Technical Service Bulletin: TSB190018	Released Date: 25-Mar-2019
Lubricating Oil Pumps with Unexpected Oil Pressures

Lubricating Oil Pumps with Unexpected Oil Pressures

Figure 2, New Lubricating Oil Pump with Threaded Regulator Plug.

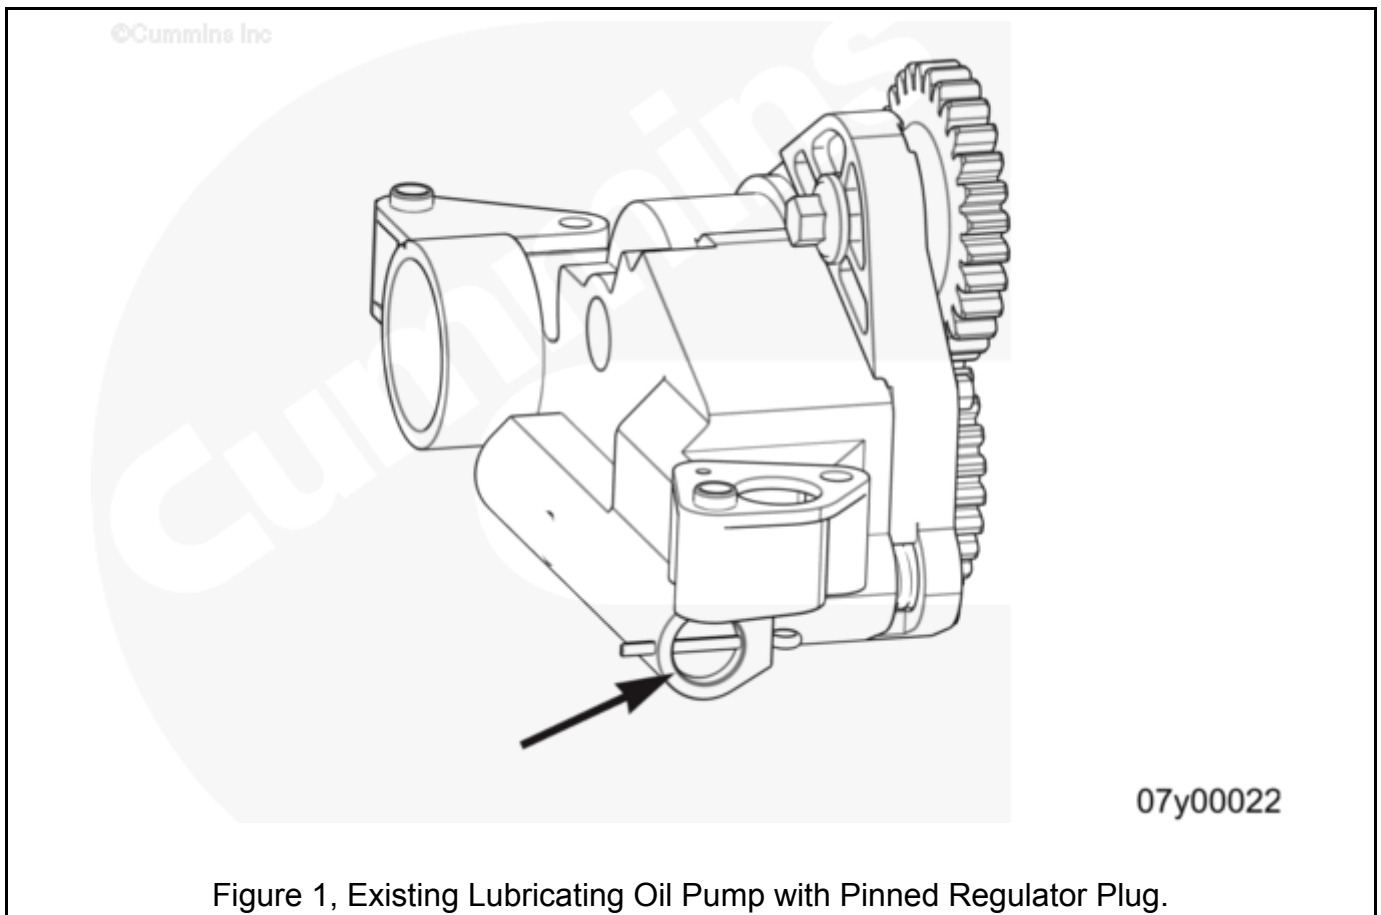
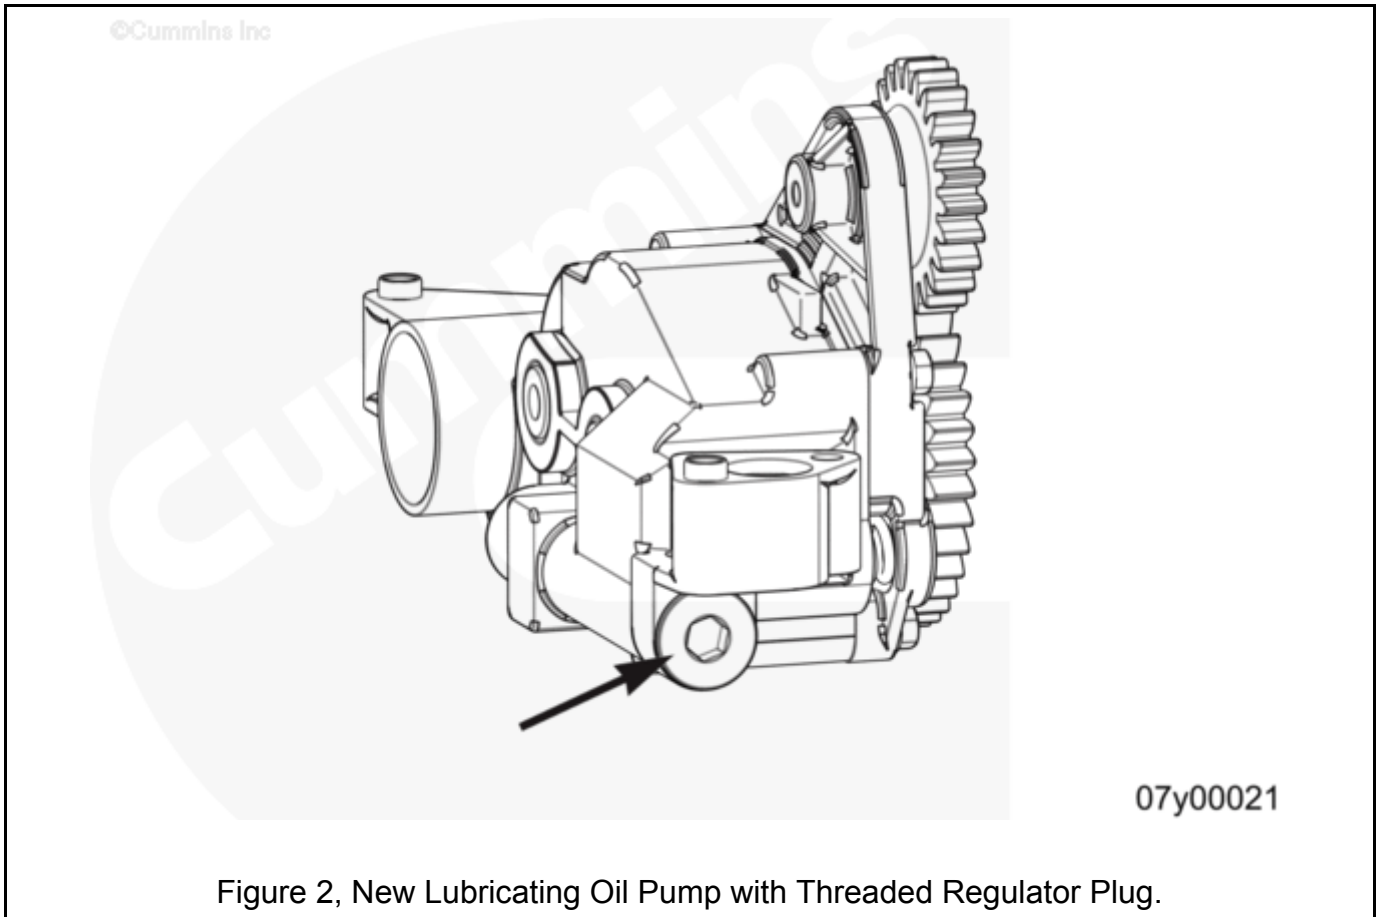
Lubricating oil pumps can be identified by the style of the regulator plug on the bottom of the lube pump. The new pump has a threaded plug. Existing pumps have a pinned plug. Pumps can also be distinguished by part numbers on the pump housings. See Figures 1 and 2 below.

New lubricating oil pump is backwards compatible, and interchangeable on engines using existing lubricating oil pumps. New pump does **not** use shims to set gear lash. For instructions on measuring and setting gear lash, see corresponding Service Manuals. Reference section 007-031.
